**DESIGN REVIEW BOARD – SPECIAL HEARING**

**Design Review Board Case # 2021-0001**  
**Block 23 – 2121 and 2111 Eisenhower Avenue**

<b>SUMMARY OF JUNE 17<sup>TH</sup>, 2021 SPECIAL HEARING:</b>  The Board’s comments followed a presentation by Applicant on the conceptual massing, form and expression of the project, as proposed. The Board agreed with the overall changes to the massing strategy based on Staff’s recommendation. They however emphasized that the Applicant should work to simplify the façade systems, particularly for the first phase, and suggested introducing secondary and tertiary expressions. The Board also expressed simplification of the block in its entirety and for less brutal facades along the new east/west service road in the rear. The Board supported bringing the tower architecture to the pedestrian realm as well as improving connections to the active “people functions” beginning on the ground level. The Board also desired more activated roof/terrace level space, given the grandeur and scale of the project. The Applicant’s Attorney concurred and clarified that these design details (i.e., related to roof-level activation) were actively being considered. The Board

*Figure Above: Applicant’s initial massing proposal, showing parallel tall sections aligned N-S, with City staff markup.*

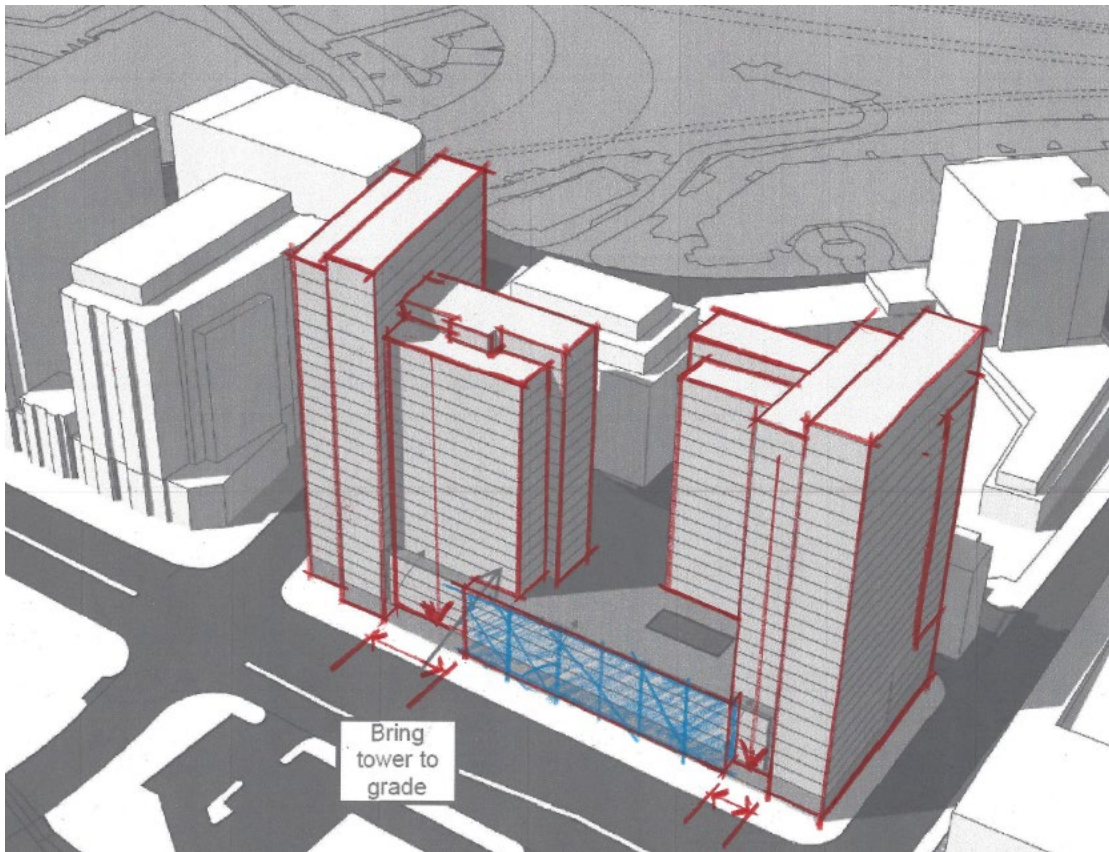
Staff encouraged the Applicant’s design team to explore placing the buildings in a rotated relationship, to create a richer combination of forms – specifically, to let the dominant bar of one remain oriented north-south, while flipping the dominant bar of the other tower to

an east-west alignment. Staff further encouraged applicant to develop strongly differentiated skin treatments for each tower, to carry tower architecture all the way to the ground wherever possible, and to use the portion of the screened garage that fronts on Eisenhower Avenue to create an element that reads as strongly different from the two towers (for example, horizontal in emphasis, and possibly much more glassy in terms of cladding) with the goal of further emphasizing the dramatic height of the two new residential towers.

**A-316**

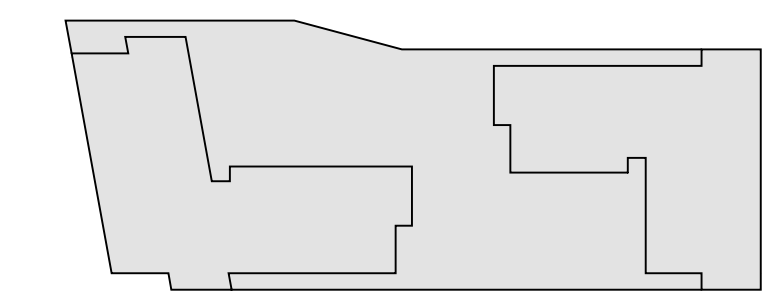
While staff appreciates that significantly more detail has been shown in balcony railings where they are proposed, the universal use of a simple vertical picket design (as seen on Sheets A-316, 317, 318, 504) makes these potentially strong design elements appear generic. Since the project has been divided not only into two separate towers, but those towers in turn subdivided into strongly differentiated components, staff suggests developing a series of related but special and distinct railing types, to be used in a coordinated way in conjunction with different façade, material or orientation conditions, with a clear rationale for which rail designs are used where.

**A-320**

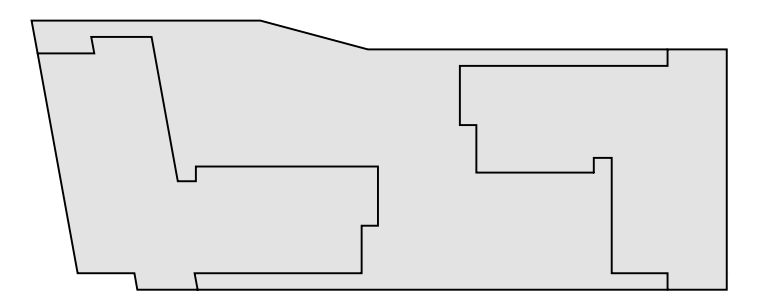
The façade treatment of the exposed podium along the Service Road (“C Street”) still appears awkward, as seen in Sheets A-321 and A-322, due to both the form and material use. In the context of the crisply geometric expression of the remainder of the project, the slight angular fold of the wall seems weak, and there is also a missed opportunity for the introduction of more glass. Staff suggests eroding the portion of the podium façade east of the bicycle rooms on the upper garage levels to create a stepped façade more in keeping with the tower massing, and also to incorporate more glass into the bicycle areas. Clarification on pedestrian access to the related ground level areas along the C Street is also necessary. Refer to diagram in **Attachment A**.
